To: Plan Holders for Improvements to the  
Kennett Regional Airport  
Kennett, Missouri  
MoDOT Project No. 19-079C-1

Transmitted herewith is Addendum No. 1 to the Issued for Bid Contract Documents, Specifications, and Plans dated August 19, 2019, for improvements to the Kennett Regional Airport Schedule I, Runway 2/20 lighting system rehabilitation; Schedule II, Navigation Aids Rehabilitation; and Schedule III, Taxiway A Lighting, including:

**ADDENDUM NO. 1  
TO  
CONTRACT DOCUMENTS, SPECIFICATIONS AND PLANS  
FOR IMPROVEMENTS TO THE  
KENNETT MEMORIAL AIRPORT  
KENNETT, MISSOURI  
PROJECT NO. 19-079C-1**

E203

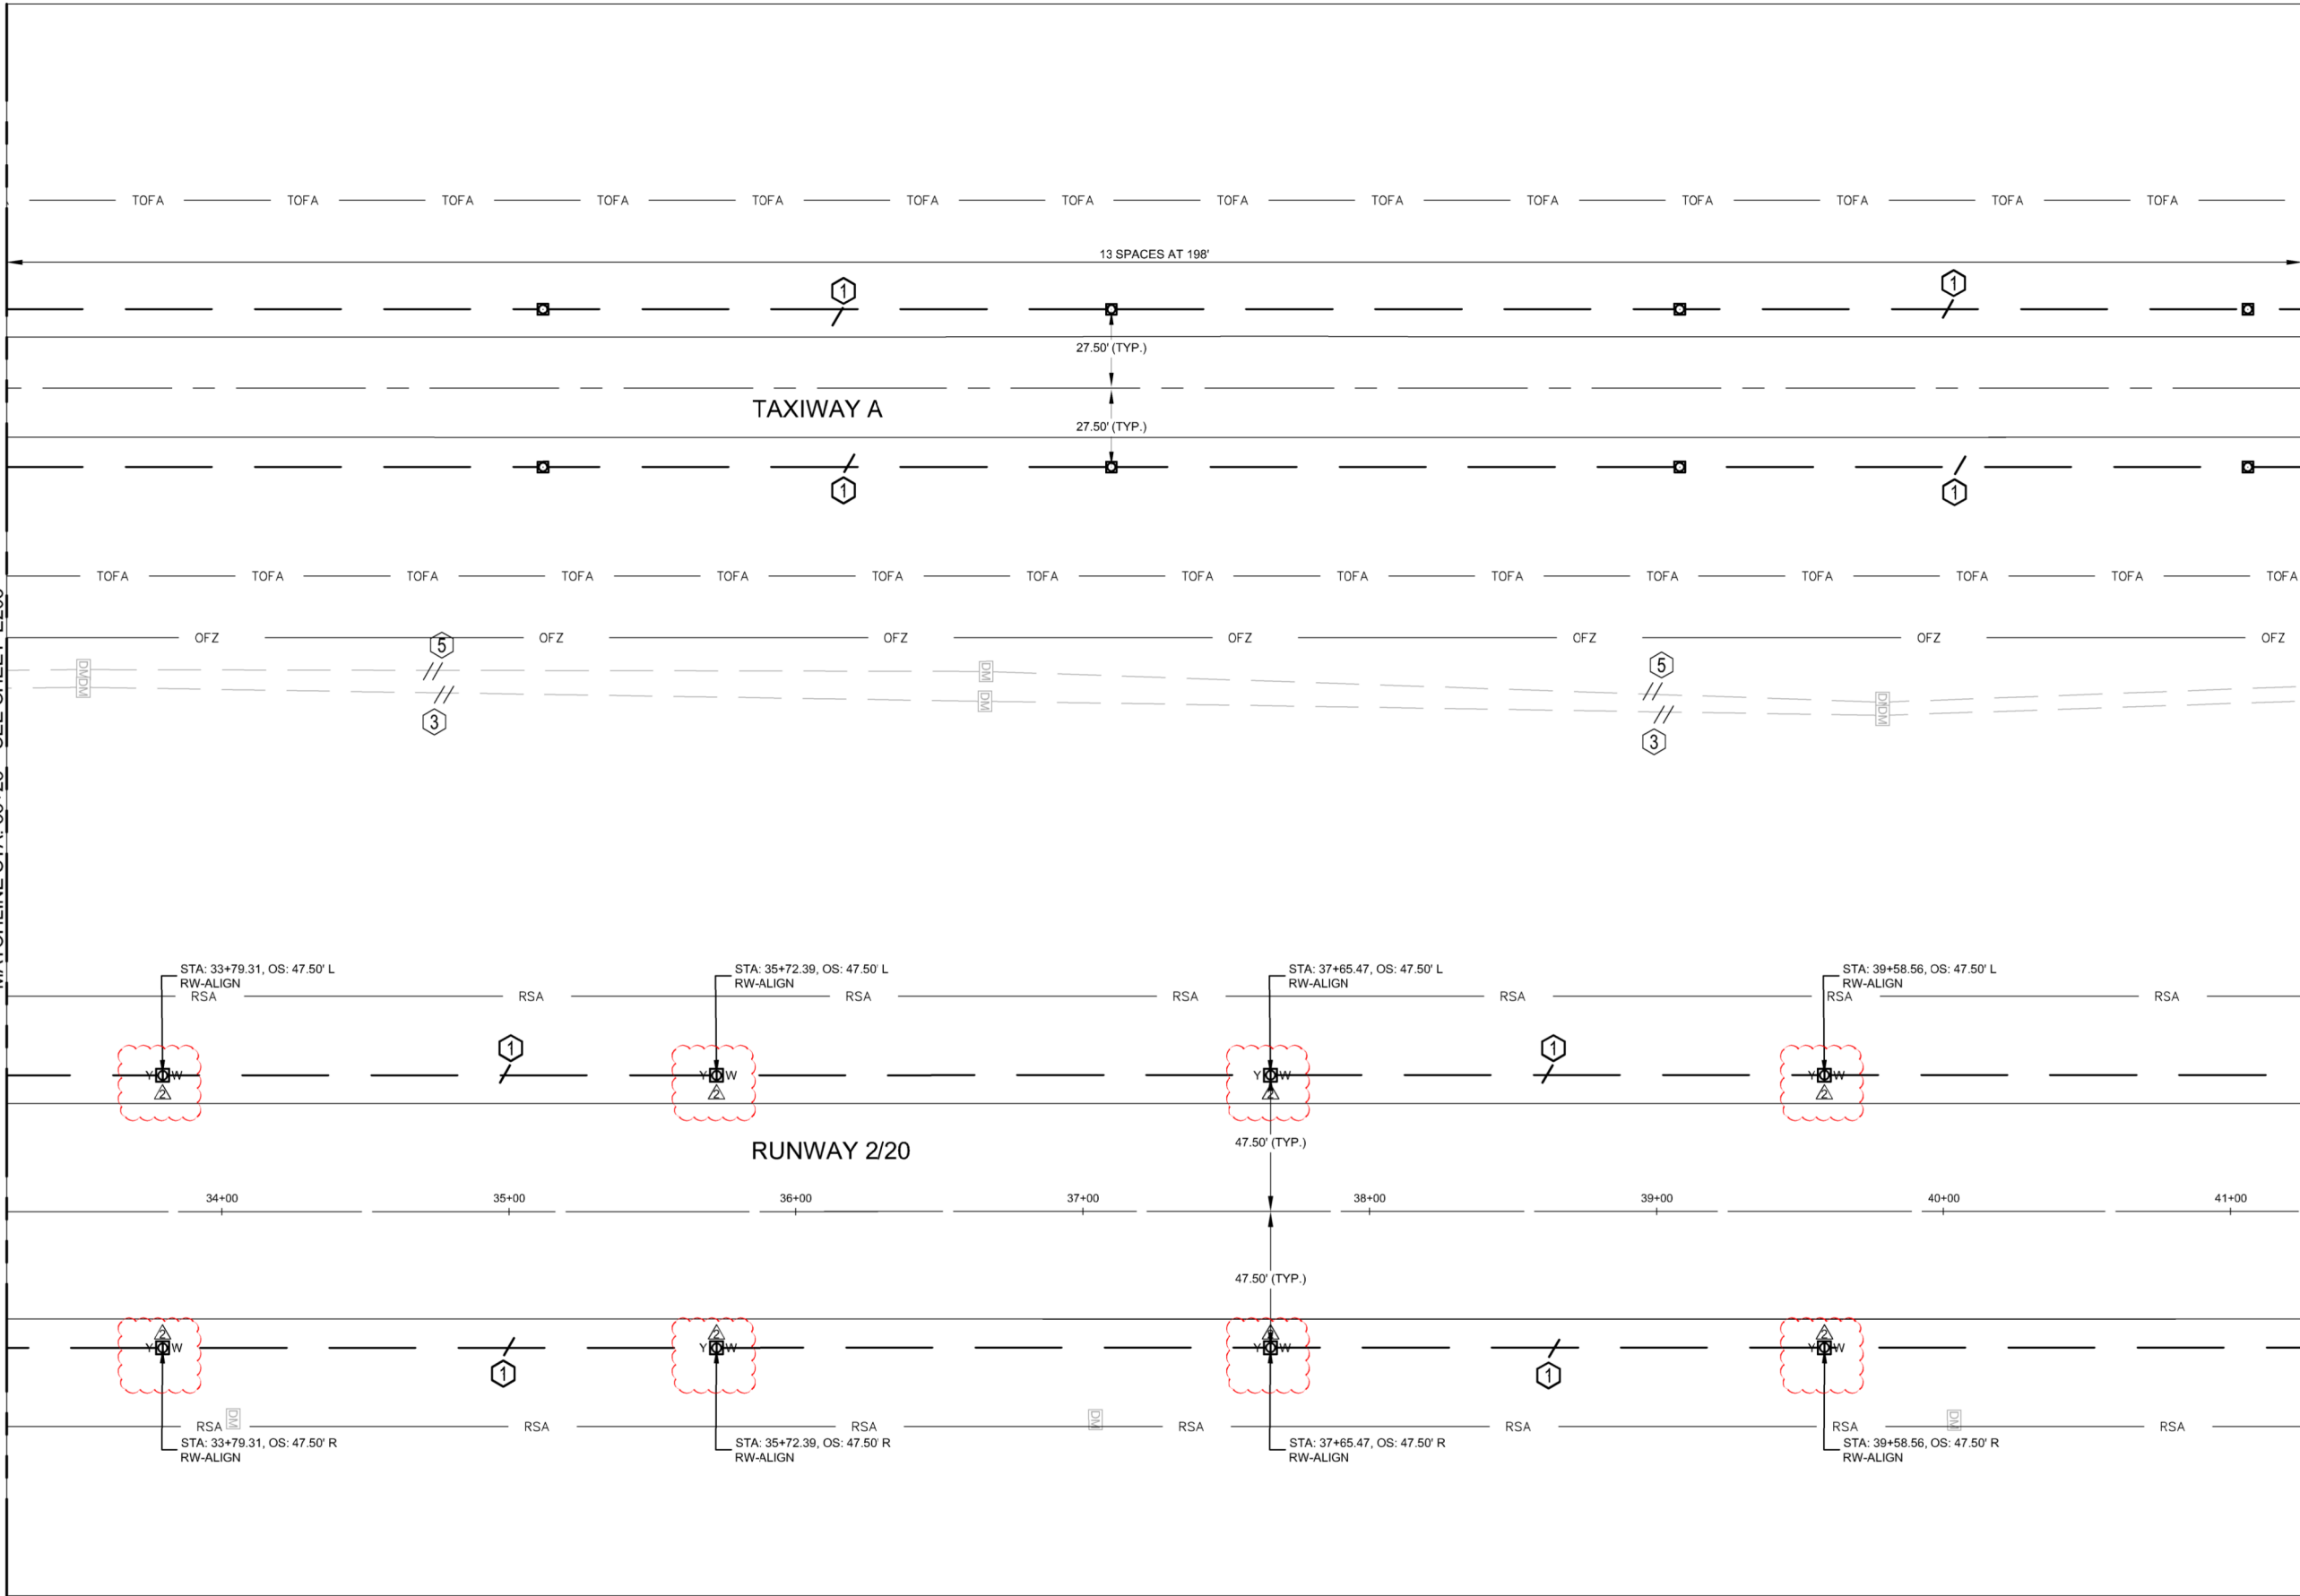
**E203/E204/E205/E207: Runway light fixture lense color change.**

*Justification: The lense colors for the runway light fixtures were updated to show the correct orientation of the clear/yellow lenses.*

7 PAPI POWER EQUIPMENT RACK DETAIL  
N.T.S.

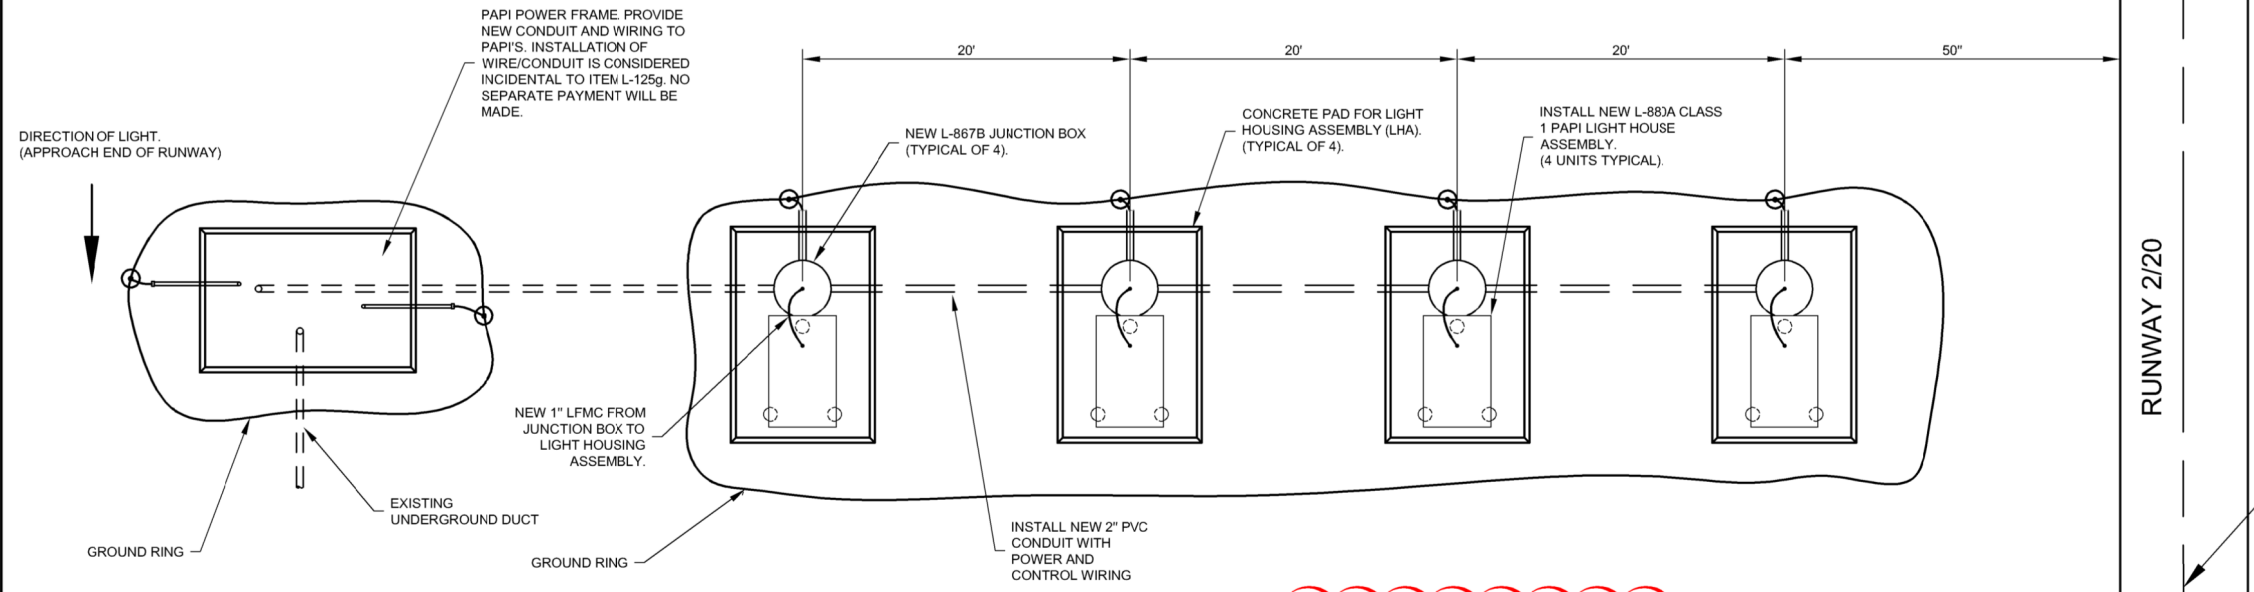
**E251: Detail 7 – Note 2 was added to the detail. The note adds a transformer to the Runway 20 PAPI installation.**

*Justification: The existing transformer was removed and a new transformer is needed to step down the voltage from the vault building to 240V.*

8 PAPI LIGHT UNIT LAYOUT  
N.T.S.

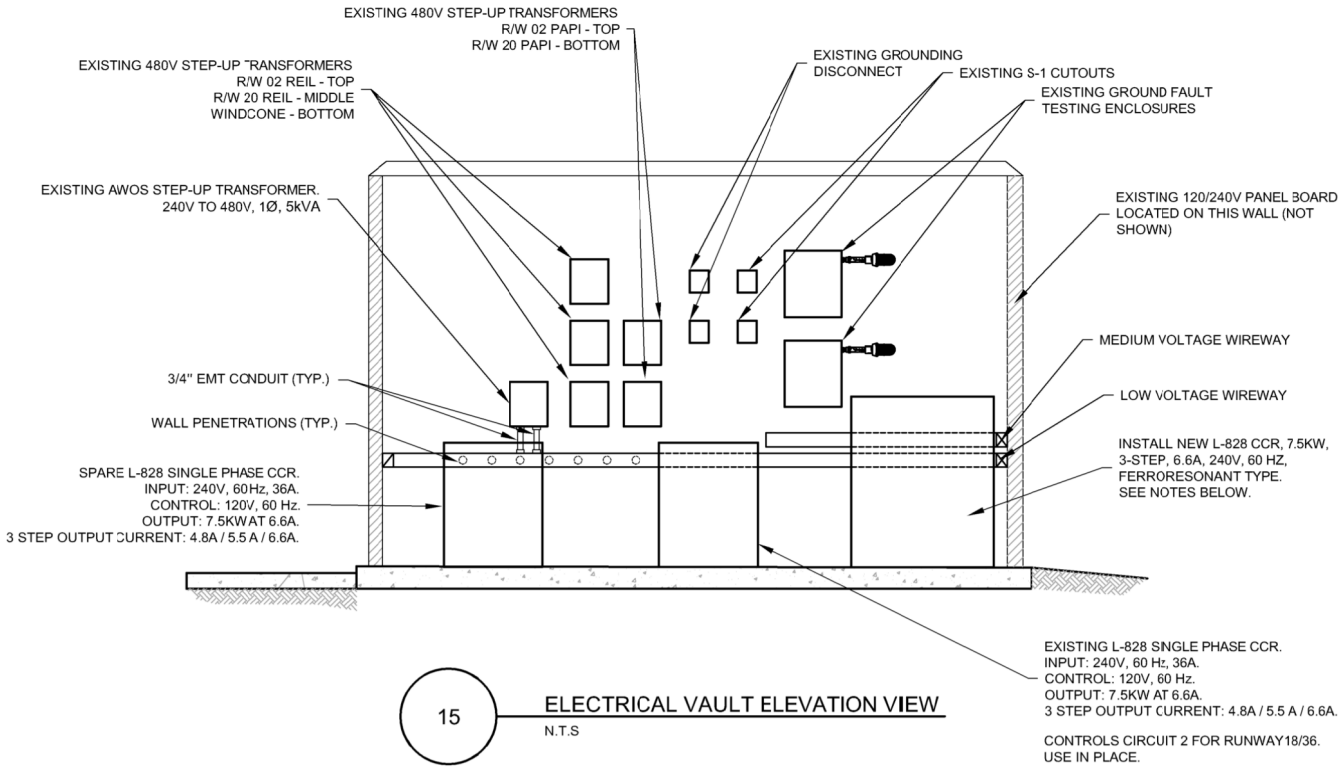
**E251: Detail 8 – Note was added to show that incandescent PAPIs will be acceptable.**

*Justification: Incandescent PAPIs will be acceptable on this project.*

NOTE:  
INCANDESCENT PAPI UNITS ARE ACCEPTABLE.
